Part of the Energy Queensland Group

Operational Update

Process Change – LV Drop Requirements

Issue # C-0060 – 7 August 2024

ERGON Configuration

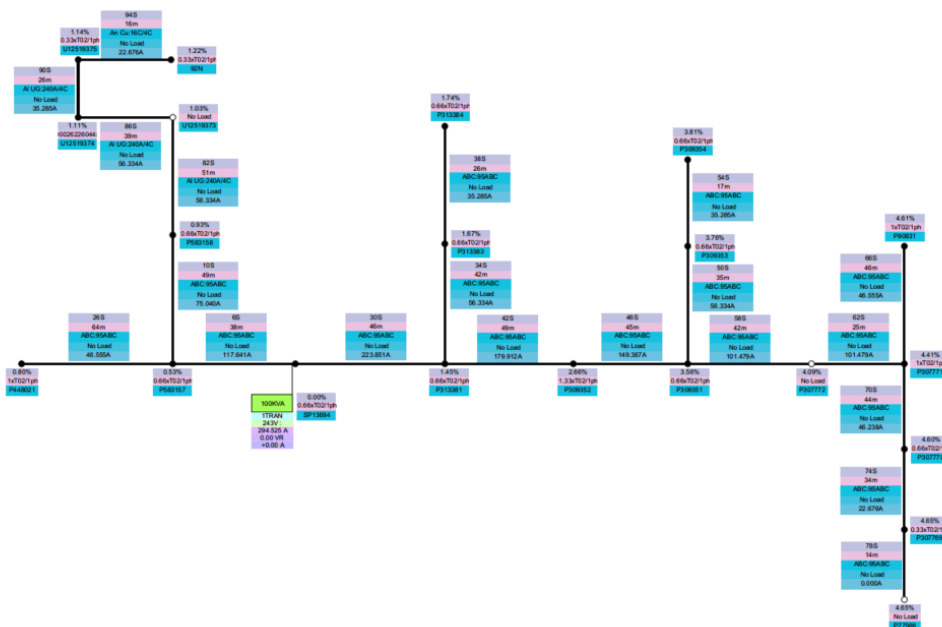
230V Source / 230V Nominal, Low Impedance Transformers utilised

Note: The published settings in Appendix G of the Joint Supply and Planning Manual are superseded by the information provided in this operational update.
